ORIGINATION FORM

Proposed Revisions to a Standard Plans Index (Please provide all information — Incomplete forms will be returned)

Index Number: 548-020

Index Title: MSE Retaining Wall Systems - Permanent

FDOT MSE RETAINING WALL CLASSIFICATION TABLE

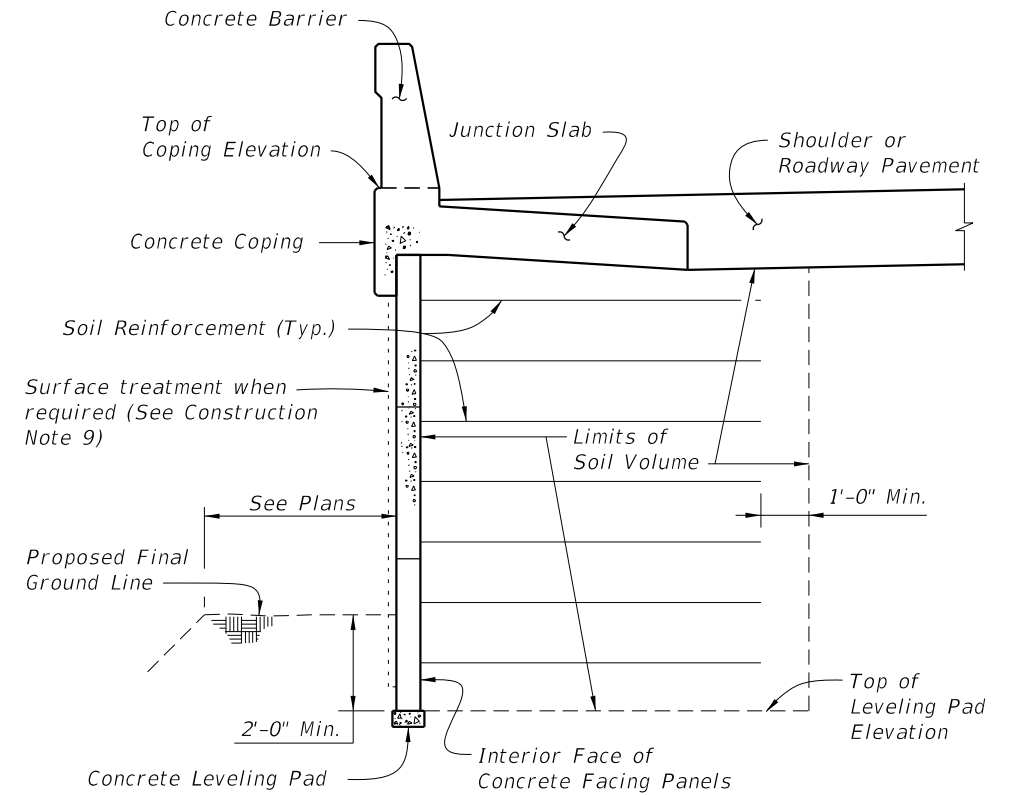
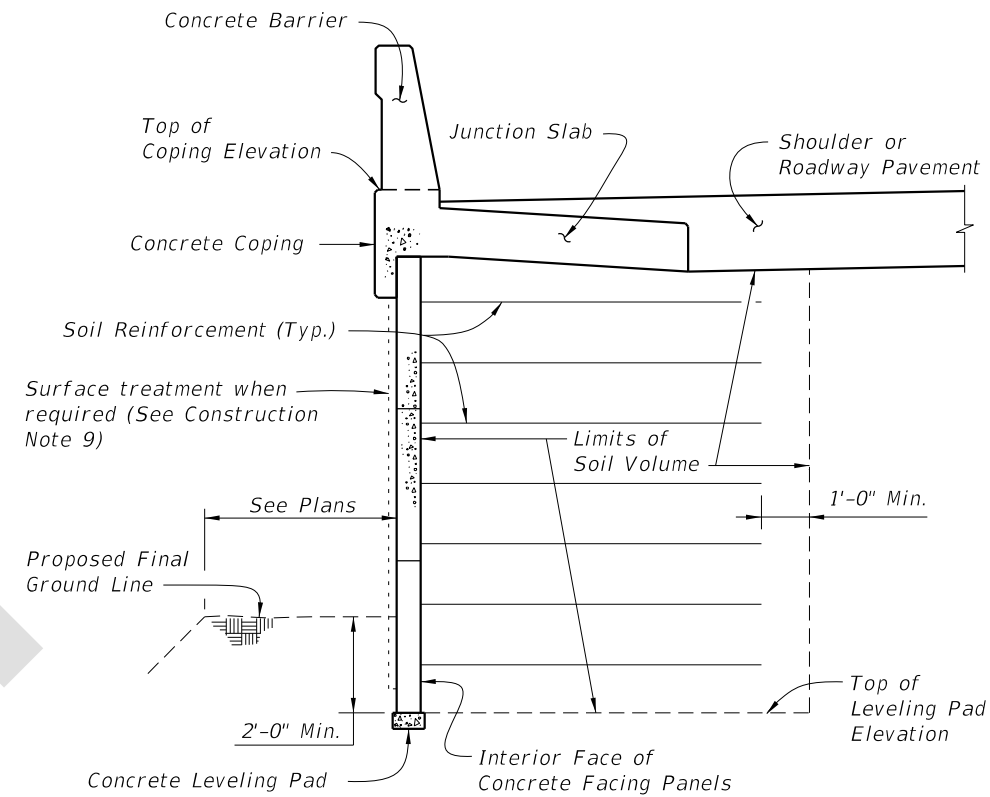
Removed alternative allowable wall type 2E from 2D.

Type 2E walls may not be able to accommodate the more aggressive environment condition that the type 2D is designated for per Dongming White.

Remove checkmark
